Addendum No. 2

Reference: Regional Training Institute – TASS Phase 2
Utah National Guard – Camp Williams, Utah
DFCM Project No. 11020480

ISSUE DATE:	1 April 2013
RESPONSE TO:	Contractor Requests for Information & DFCM Comments
PROJECT:	**RTI TASS Complex, Phase II** **Administration & Billets Buildings** 17800 South Academy Street Utah National Guard Camp Williams **DFCM'S PROJECT #:** 11020480 **NGB'S PROJECT #:** 490444 **ARCHITECT'S PROJECT #:** 11024
OWNER:	**Utah National Guard** 12953 South Minuteman Drive Draper, Utah 84020-1726
SUBJECT:	**VARIOUS CLARIFICATIONS**
ATTACHED:	**VOLUMES A.1 & A.2**

B2 SF101 ADDITIVE / ALTERNATE MAIN LEVEL FLOOR FRAMING PLAN
SCALE: 1/8" = 1'-0"

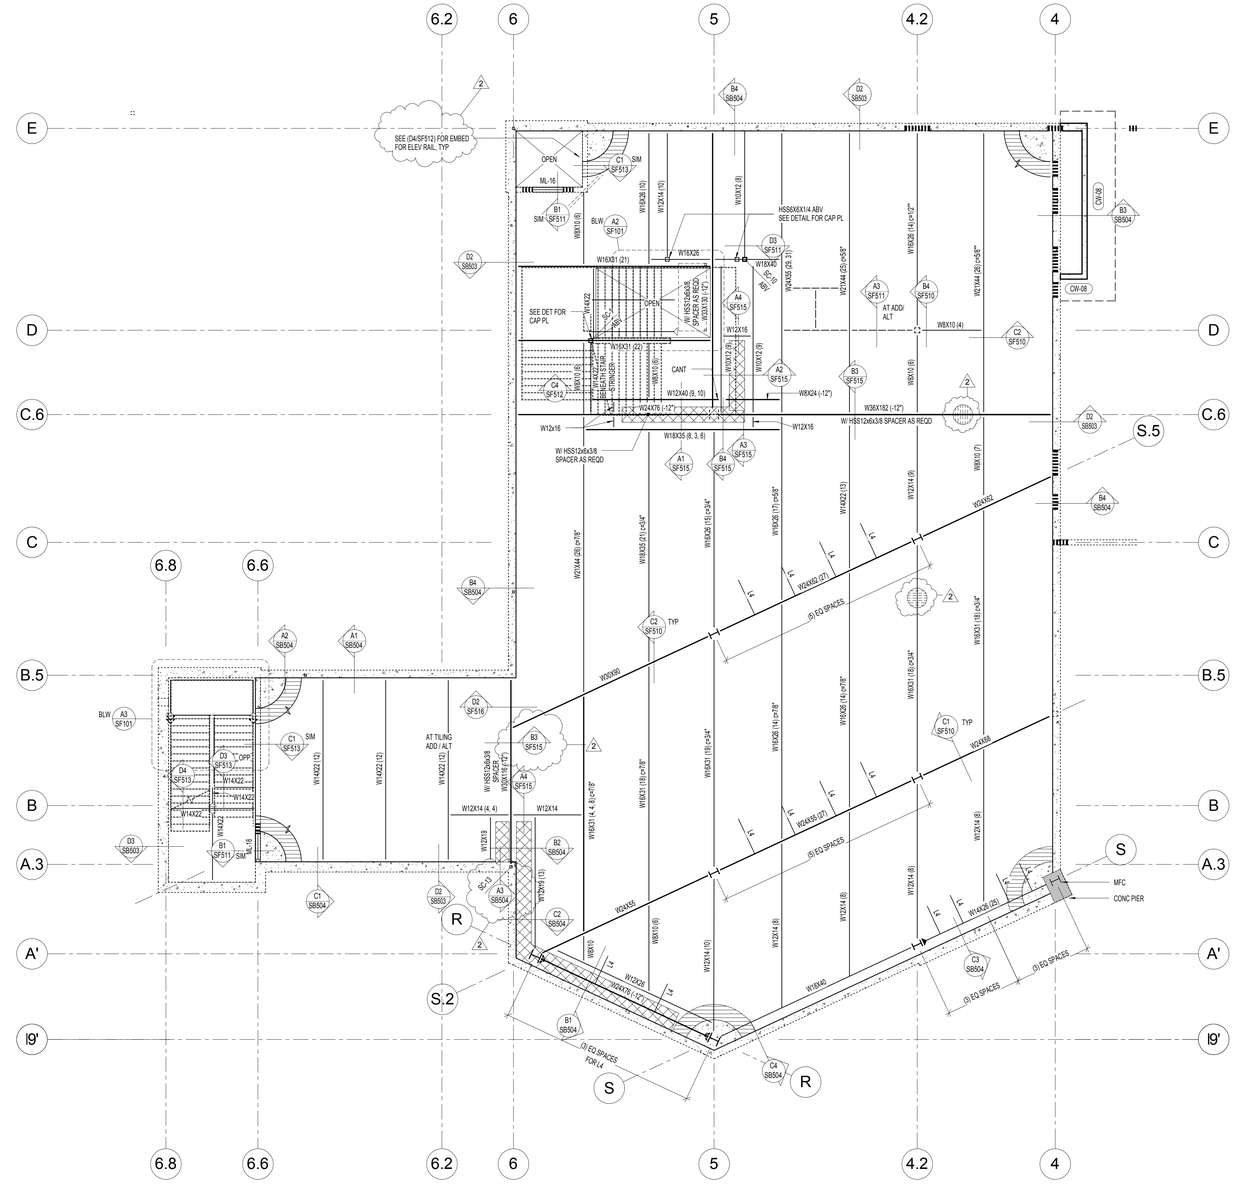
9. Drawing SF101 – Corrected detail callouts. Added detail callout. Added symbol for slab reinforcing over beams framing into columns to plan and to Marks and Symbols Legend.

C1 SF104 PARTIAL SECOND FLOOR FRAMING PLAN
SCALE: 1/4" = 1'-0"

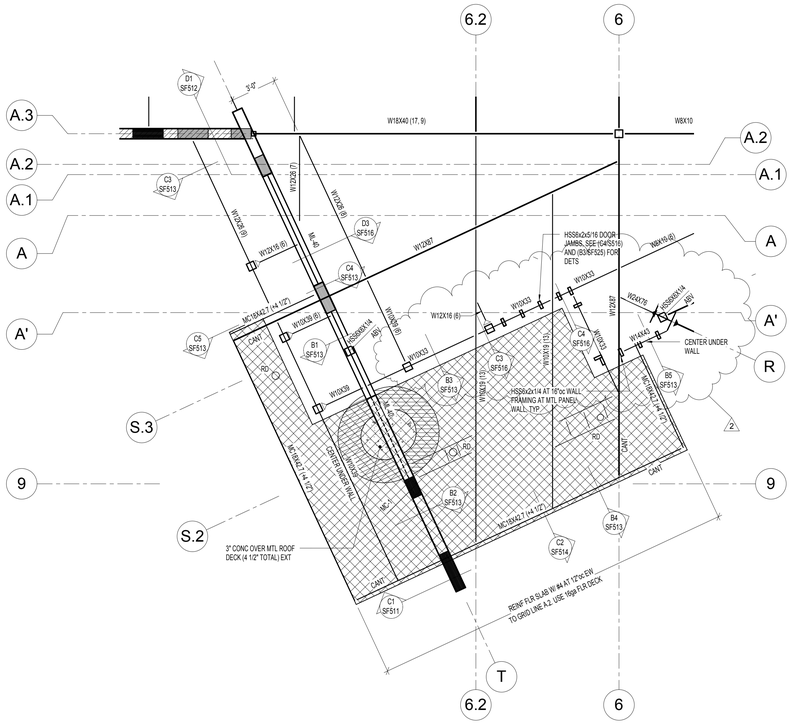
12. Drawing SF104 – Revised beam sizes.

A1 LEVEL 2 - FLOOR PLAN
AE102 1/8" = 1'-0"

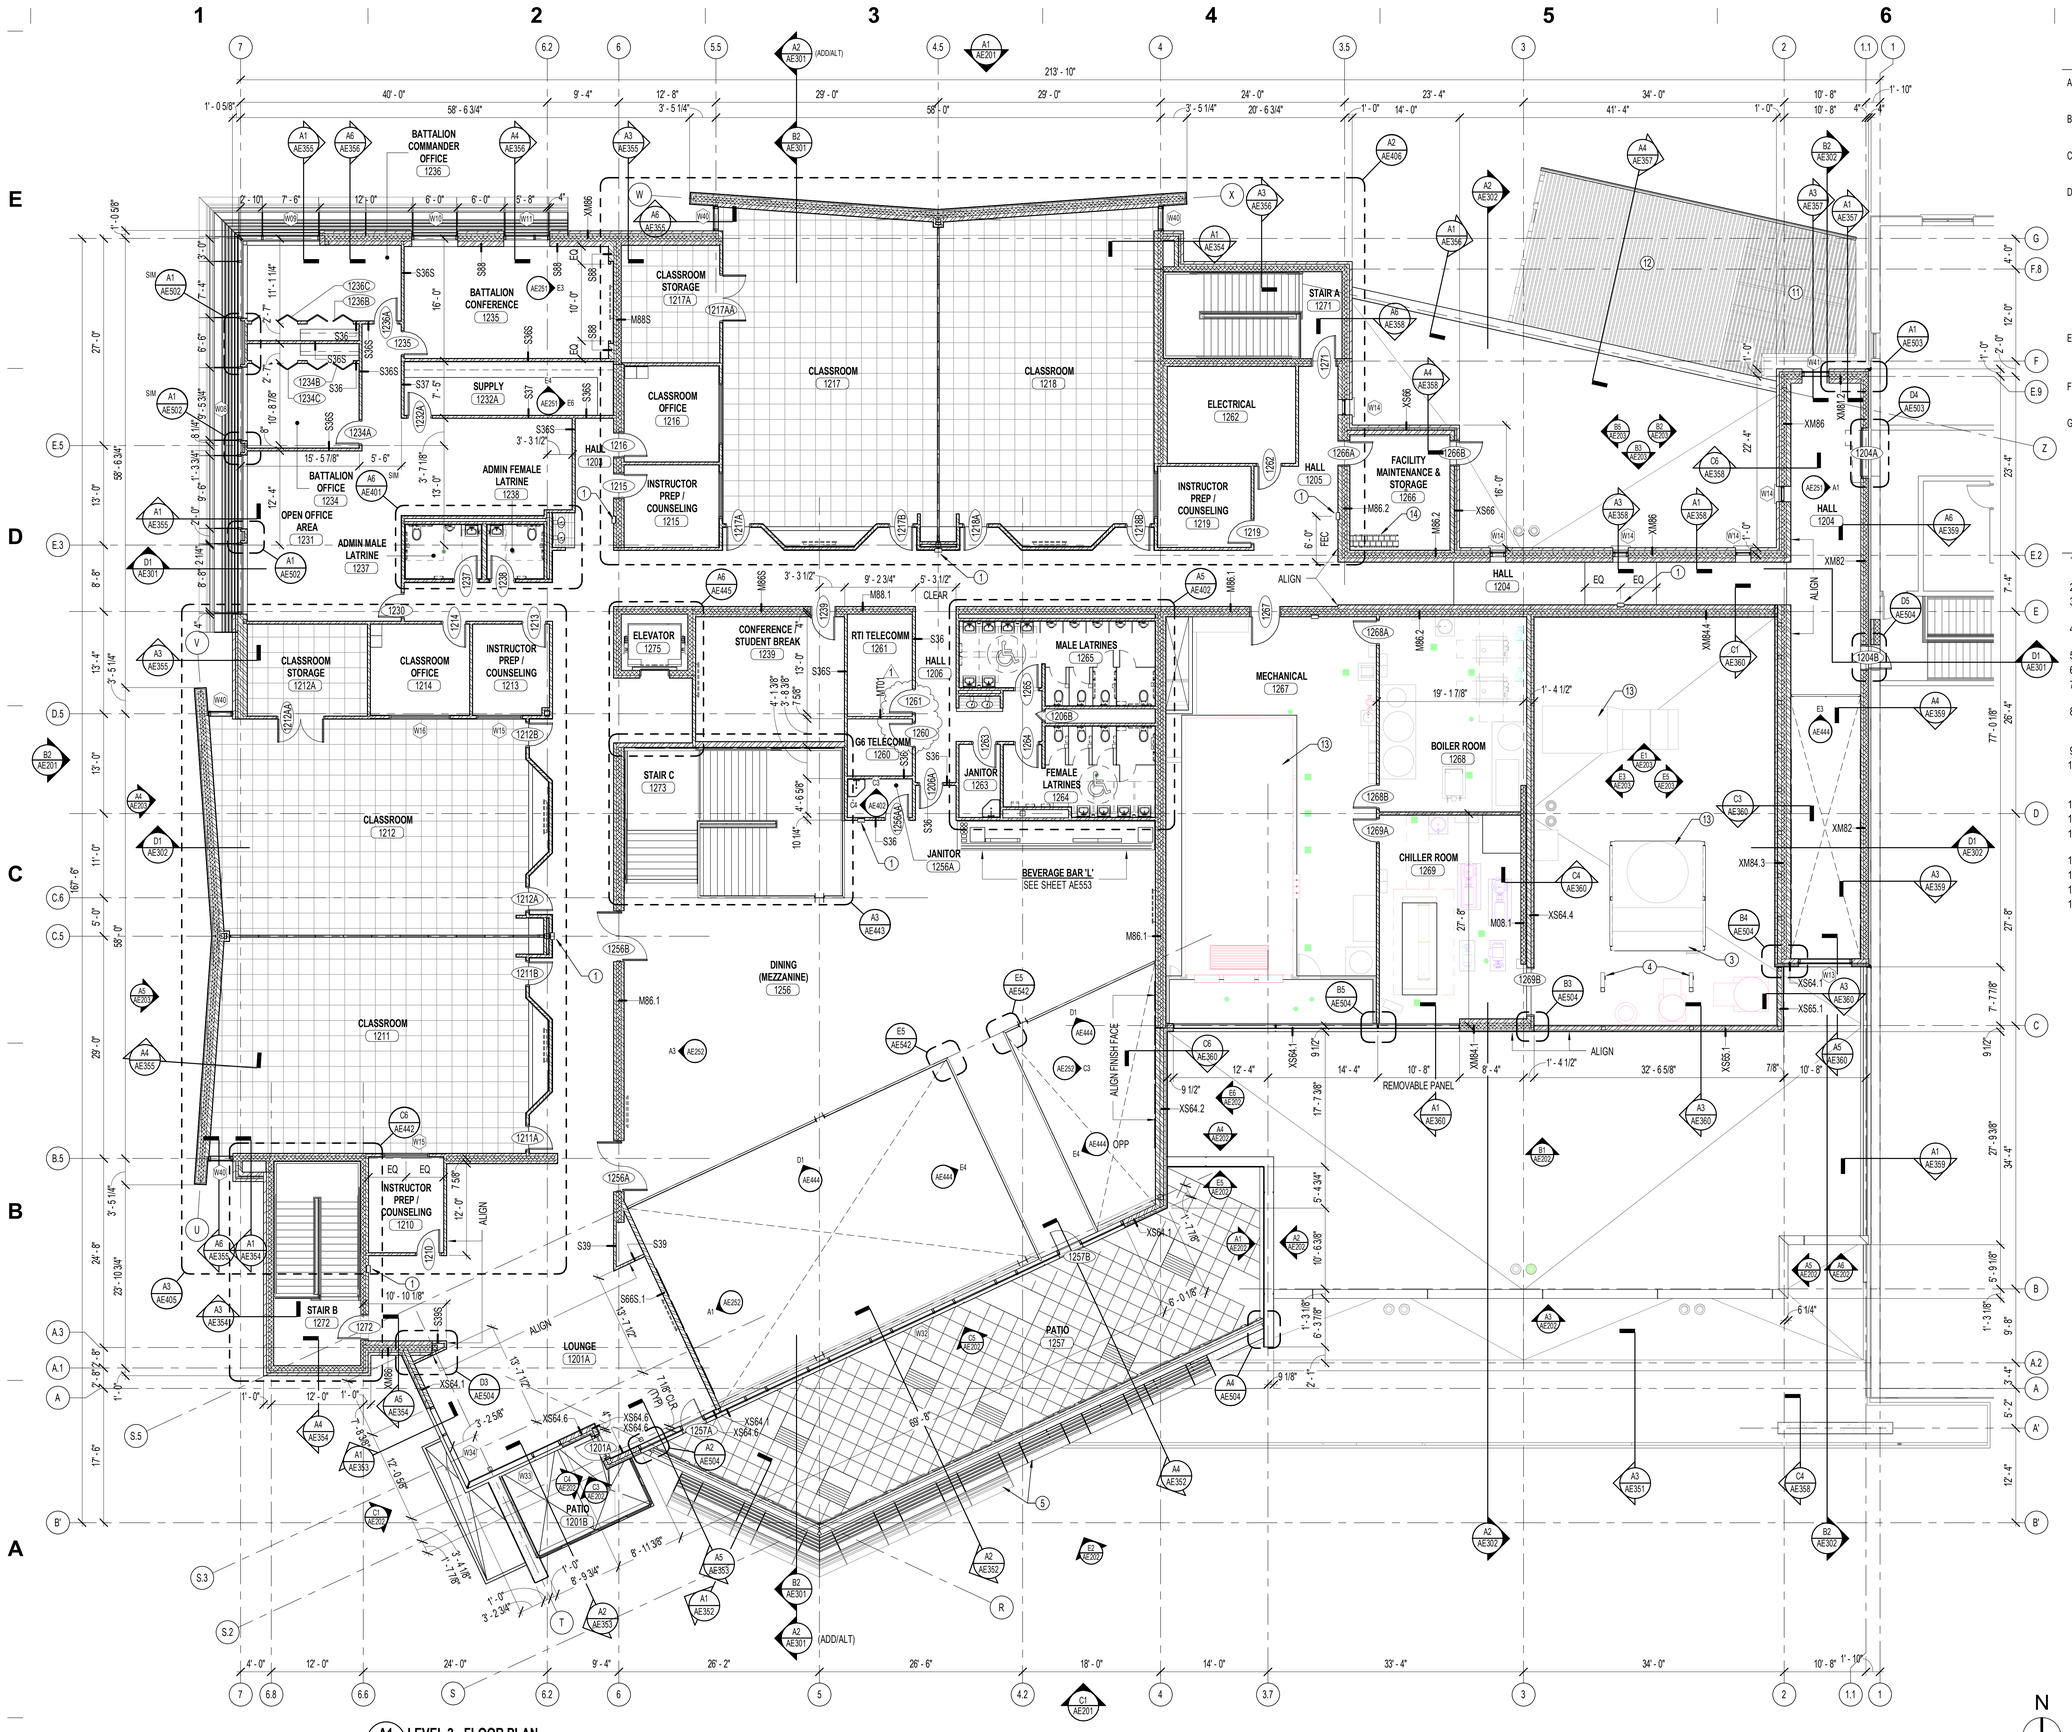
A4.05	AE102	**REVISE** doors 1260 and 1261 to swing into their respective rooms, as shown in sheet provided.
A4.06	AE358	**ADD** wall section C3/AE358, as shown in sheet provided.
A4.07	AE359	**ADD** seismic separation dimension to walls sections A1, A3, A4, and A6/AE359, as shown in sheet provided.
A4.08	AE251, AE252, AE401, AE402, AE403, AE404, AE405, AE403	**ADD** keynote #21 to KEYNOTE – INTERIOR ELEVATION schedule, to read as follows: "21. KITCHEN HOOD"
A4.09	AE403	**ADD** keynote # 21 to details D2, D3, and D4/AE403, as shown in sheet provided. **REVISE** wall tag at plumbing wall of handwash station to be 'SS42T', as shown in sheet provided.
A4.10	AE406	**REVISE** Electrical #1162, as shown in sheet provided. Doors #1162A and #1162B have been moved to allow for proper clearance to door #1172A, and electrical panel adjustments within the room.
A4.11	AE503	**REVISE** plan detail A1/AE503, as shown in sheet provided. Rated expansion joint to be in line with rated wall construction, and an expansion cover plate provided at exterior face of walls. **REVISE** rating of 4'-0" portion to be 1-hr min construction. Wall types indicated for clarity of wall construction. **ADD** wall section marker 'C3/AE358' to plan detail D5/AE503, as shown in sheet provided.
